Rezoning Transportation Analysis

Petition Number: 2017-016

General Location Identifier: 16303224

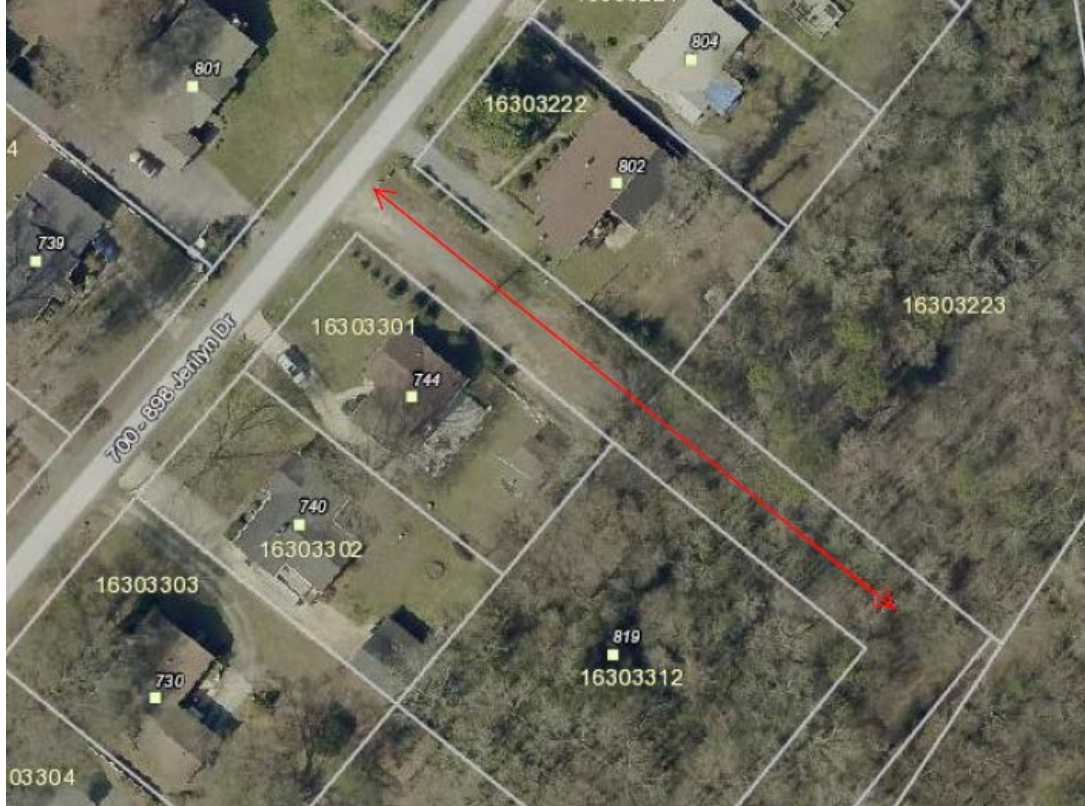
4. The petitioner should revise the site plan and the transportation notes to show installation of 12' wide sidewalk along all property frontages on Long Avenue, Monroe Rd., and Idlewild Rd. In addition, CDOT is requesting 12' wide sidewalk within the existing City right of way that exists between Long Avenue and Jerilyn Dr. Since sidewalks are required in these locations already (with exception to the paper ROW) CDOT is requesting that they be wider in these locations to accommodate the Independence Sidewalk and Bikeway project. CDOT recognizes that this is an added expense. However, CDOT feels that there is value to the developer to have the future multi use path run along the frontage of their property. This segment of 12' wide sidewalk could serve as a key segment to the future multi use path corridor that will be created by the ISB Project. This important multi use path will connect commercial uses in this area to residential neighborhoods for miles. If the wide sidewalk is not constructed with this project there is a good chance that whatever is built will be demolished and reconstructed at a later date by the ISB Project. Therefore CDOT feels it is practical to install the wider sidewalk as a part of this development. CDOT proposed 12' sidewalk as seen below represented by the blue line:
